August 31, 2017 NRC-17-0067

- Reference: Fermi 2 NRC Docket No. 50-341 NRC License No. NPF-43
- Subject: Application to Revise Technical Specifications to Adopt TSTF-542, <u>"Reactor Pressure Vessel Water Inventory Control"</u>

Enclosure 1 to NRC-17-0067

License Amendment Request to Adopt TSTF-542, "Reactor Pressure Vessel Water Inventory Control"

INSERT New LCO 3.5.2, CONDITION C and D

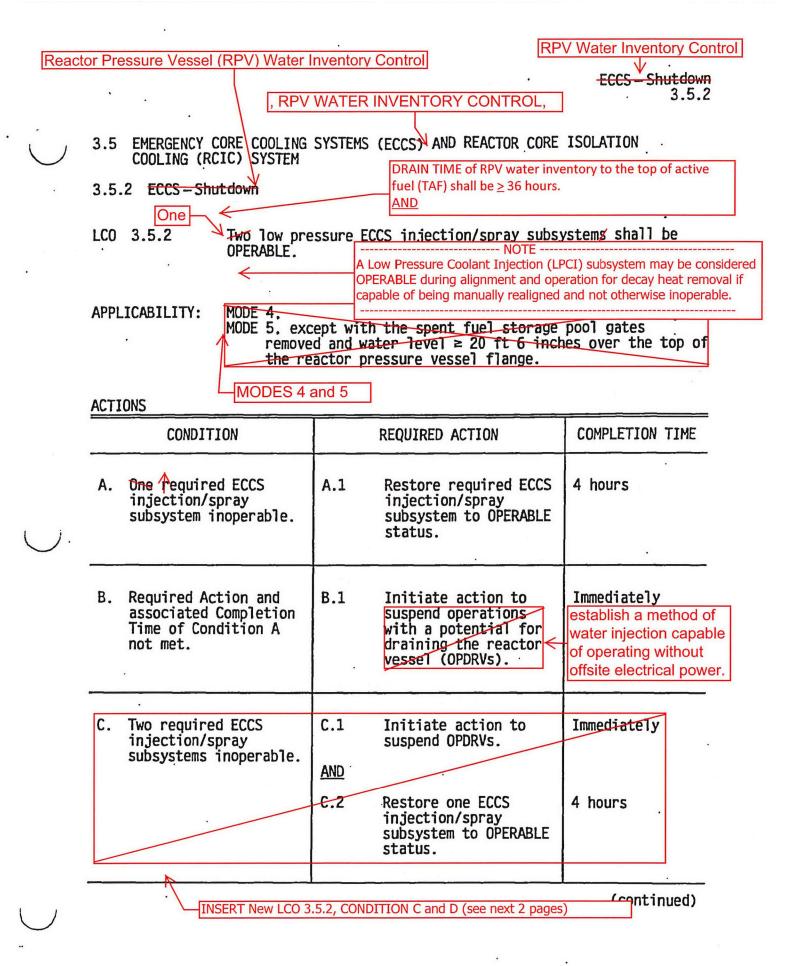
CONDITION	REQUIRED ACTION	COMPLETION TIME
C. DRAIN TIME < 36 hours and <u>></u> 8 hours	C.1 Verify secondary containment boundary is capable of being established in less than the DRAIN TIME.	
	AND	
	C.2 Verify each secondary containment penetration flow path is capable of being isolated in less than the DRAIN TIME.	
	AND	
	C.3 Verify one standby gas treatment subsystem is capable of being placed in operation in less than the DRAIN TIME.	
D. DRAIN TIME < 8 hours	D.1NOTE Required ECCS injection/spray subsyster or additional method of water injection shall be capable of operating without offsite electrical power.	
	Initiate action to establish an additional method of water injection with wate sources capable of maintaining RPV water level > TAF for <u>></u> 36 hours	er ,
	AND

CONDITION	REQUIRED ACTION		COMPLETION TIME	
	D.2	Initiate action to establish secondary containment boundary.	Immediately	
	<u>AND</u>			
	D.3	Initiate action to isolate each secondary containment penetration flow path or verify it can be manually isolated from the control room.	Immediately	
	<u>AND</u>			
	D.4	Initiate action to verify one standby gas treatment subsystem is capable of being placed in operation.	Immediately

RPV Water Inventory Control

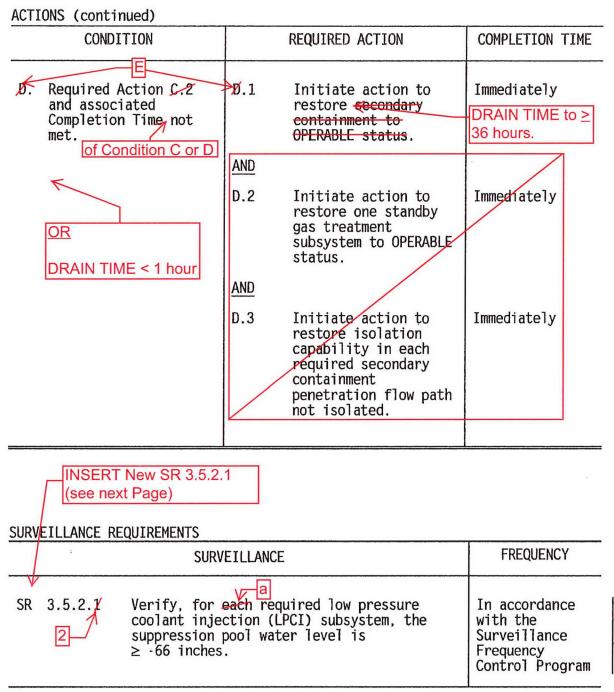
SR 3.5.2.1	Verify DRAIN TIME <u>></u> 36 hours.
------------	---

00111		SURVEILLANCE	FREQUENCY
SR	3.5.2.2	<pre>Verify, for each required core spray (CS) subsystem, the: a. Suppression pool water level is ≥ -66 inches; or b. Only one required CS subsystem may take credit for this option during OPDRVs. Condensate storage tank water level is ≥ 19 ft.</pre>	In accordance with the Surveillance Frequency Control Program
SR	3.5.2.	Verify correct voltage and breaker alignment to the LPCI swing bus.	In accordance with the Surveillance Frequency Control Program
SR	3.5.2.4	the Verify, for each required ECCS injection/spray subsystem, locations susceptible to gas accumulation are sufficiently filled with water.	In accordance with the Surveillance Frequency Control Program
			(continued)

RPV Water Inventory Control

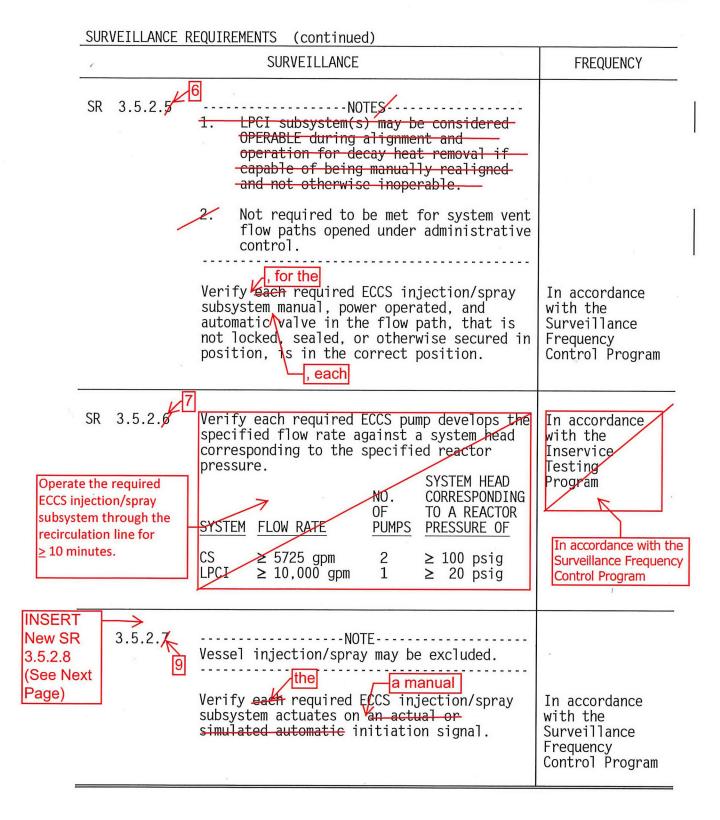
SR 3.5.2.8	Verify each valve credited for automatically isolating a penetration flow path actuates to the isolation position on	In accordance with the
	an actual or simulated isolation signal.	Surveillance
	Ğ	Frequency
		Control Program

CREF System 3.7.3

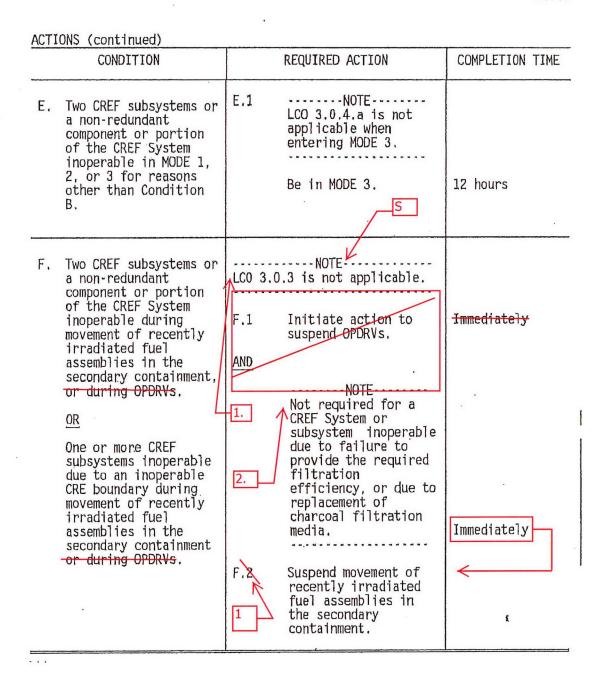
- 13. The Fermi 2 TS Section 3.7.3 for the CREF System retains the existing Note, renumbered to Note 2, in the Actions section modifying Required Action F.2. This change has no effect on the adoption of the TSTF-542 and is an acceptable variation.

CONDITION		REQUIRED ACTION	COMPLETION TIME
2.	Required Action and associated Completion Time of Condition A or B not met in MODE 1, 2, or 3.	C.1	LCO 3.0.4.a is not applicable when entering MODE 3. Be in MODE 3.	12 hours
).	Required Action and associated Completion Time of Condition A not met during movement of recently irradiated fuel assemblies in the secondary containment, or during OPDRVs.		NOTE .3 is not applicable. Place OPERABLE CREF subsystem in recirculation mode.	Immediately
	×	D.2.1 AND	Initiate action to suspend OPDRVs.	Immediately
•			Not required for a CREF System or subsystem inoperable due to failure to provide the required filtration efficiency, or due to replacement of charcoal filtration media.	Immediately
÷		D.2 💋	Suspend movement of recently irradiated fuel assemblies in the secondary containment.	<
		l		(continued
